Technical Memo

To: Kevin Pierard, New Mexico Environment Department, Hazardous Waste Bureau Chief
From: Diane Agnew, Environmental Manager, Albuquerque Bernalillo County Water Utility Authority
CC: Stephanie Stringer (NMED), Mark Kelly (Water Authority)
Date: 11/19/2020
Re: Analysis of Groundwater Monitoring with Passive Diffusion Samplers

Figure 1a.

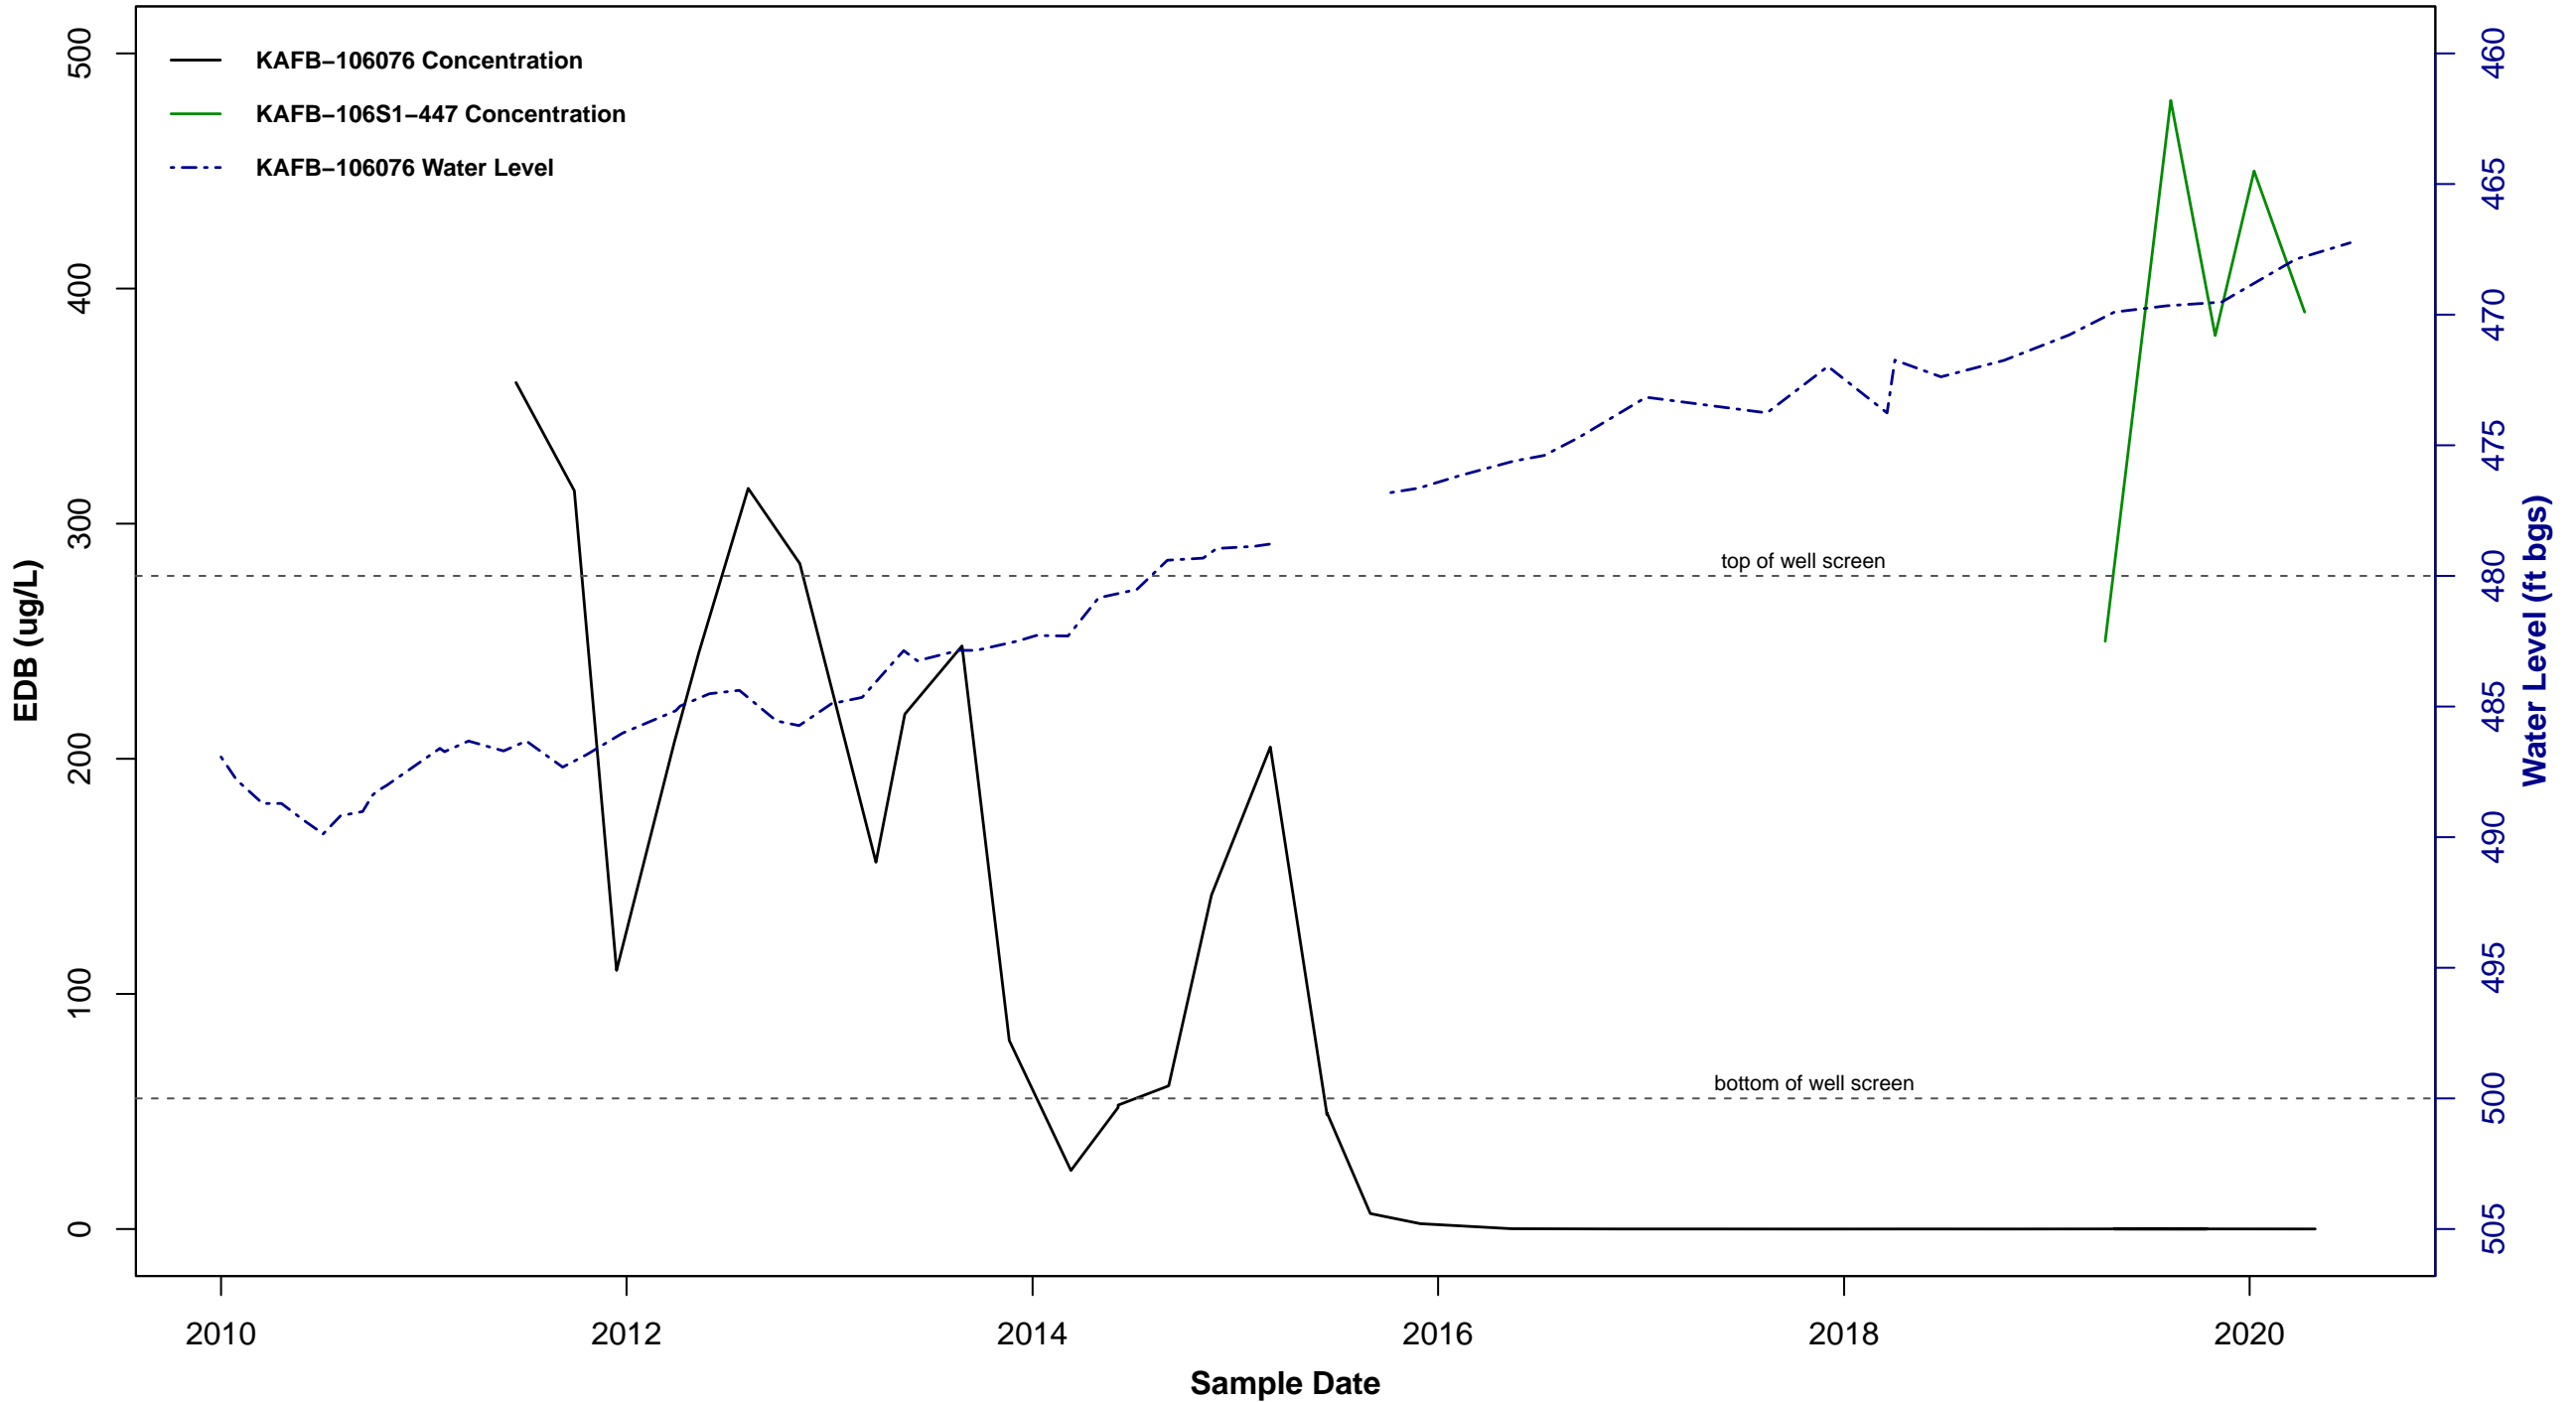
Analysis of contaminant concentrations in groundwater monitoring wells that are screened across the water table, as compared to adjacent water table wells with submerged screens, reveals evidence that the submergence of wells is the more likely explanation for the change in contaminant concentrations. For example, analysis of the replacement water table well, KAFB-106S1, compared to the adjacent, older and submerged well, KAFB-106076, shows the new water table well (KAFB-106S1) has detected contaminant concentrations at or even above historic maximum concentrations from KAFB-106076 (Figures 1a and 1b). There are additional instances where the contaminant concentrations exceed historic maximums in the newly-installed water table wells adjacent to submerged wells used by the Air Force to represent the water table.

Figure 2a.

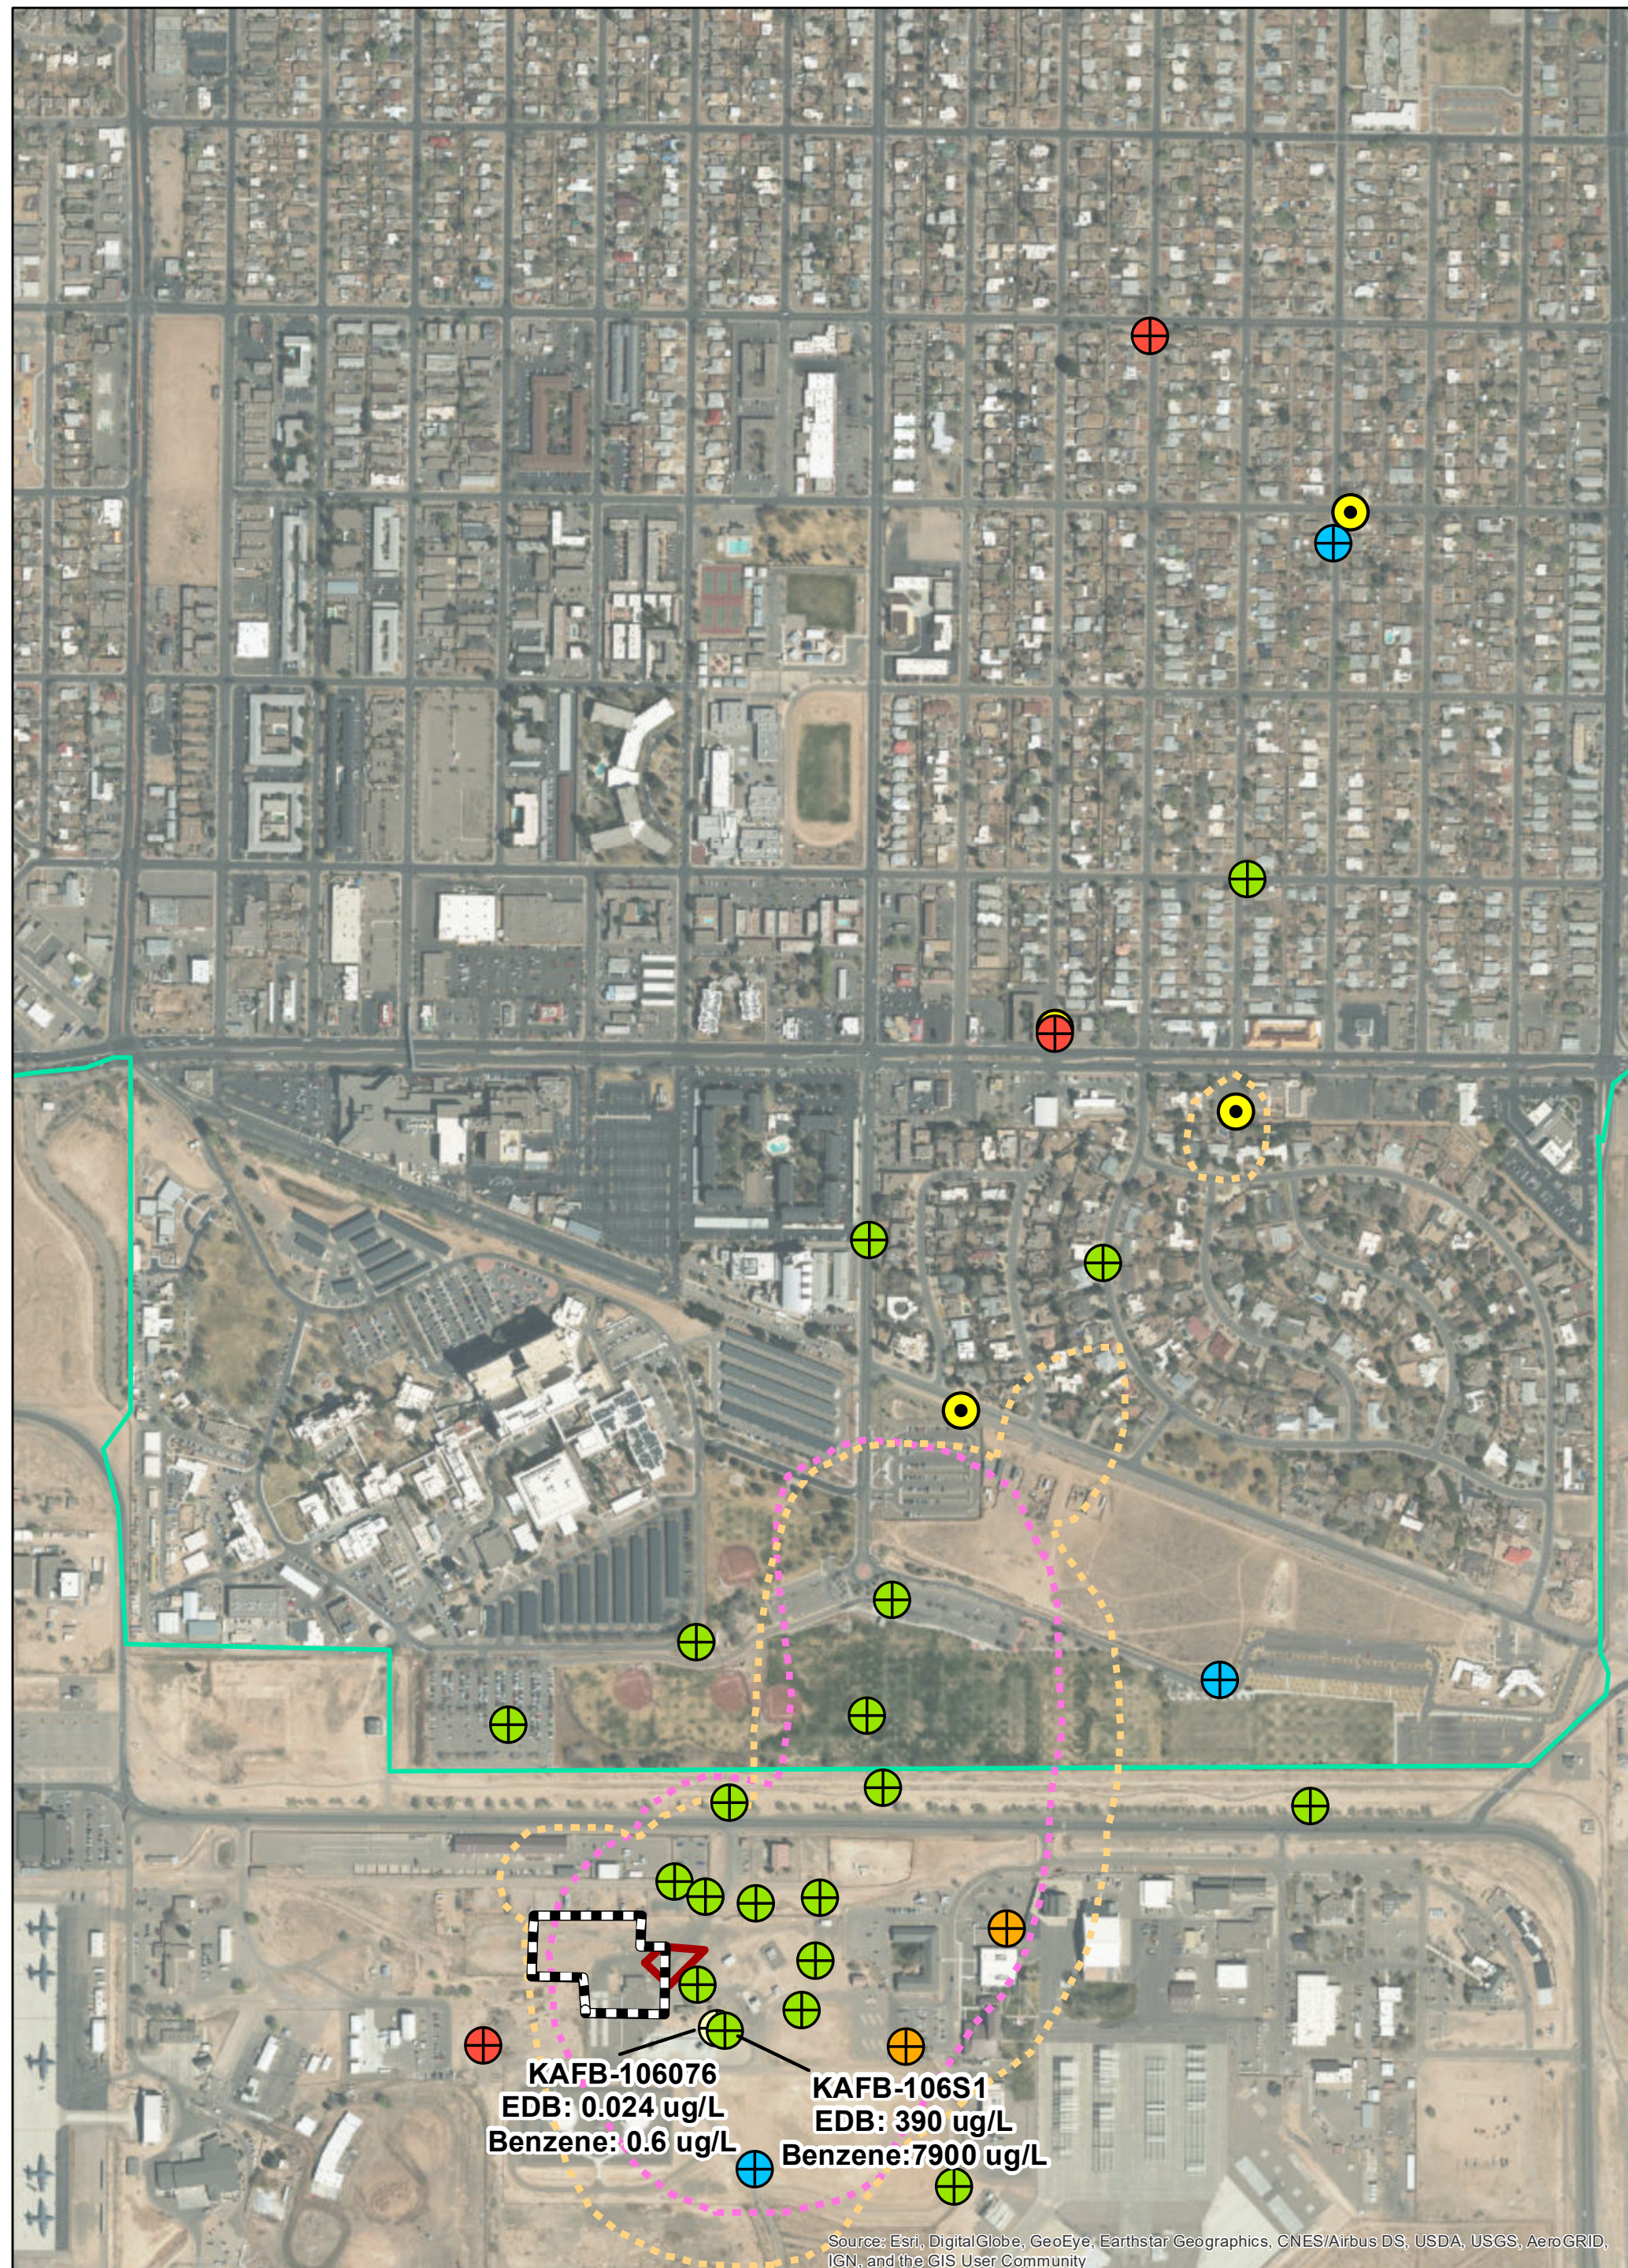
The Air Force presents its groundwater monitoring data based on three reference intervals to represent the vertical extent of groundwater contamination at the site: reference interval (REI) 4857 feet for the “water table” shallow plume, REI 4838 feet for the intermediate plume, and REI 4814 for the deep plume. Figure 2a includes the groundwater monitoring wells from Figure 3-5 from the Q2 2020 quarterly report that are reported as being representative of the water table (REI 4857), and removes wells that are submerged and no longer screened at the water table. Using groundwater elevation data from Q1 2016 through Q4 2019, the average annual water table rise is 3.3 feet (KAFB AFB 2019); Figure 2b illustrates the wells that will remain screened at the water table after applying this rate of change for two years. Table 2 summarizes the number of wells that remain non-submerged, and therefore, representative of plume concentrations at the water table.

- The continued submergence of wells screened across the water table results in a reduction of wells that can be considered representative of plume concentrations at the water table.
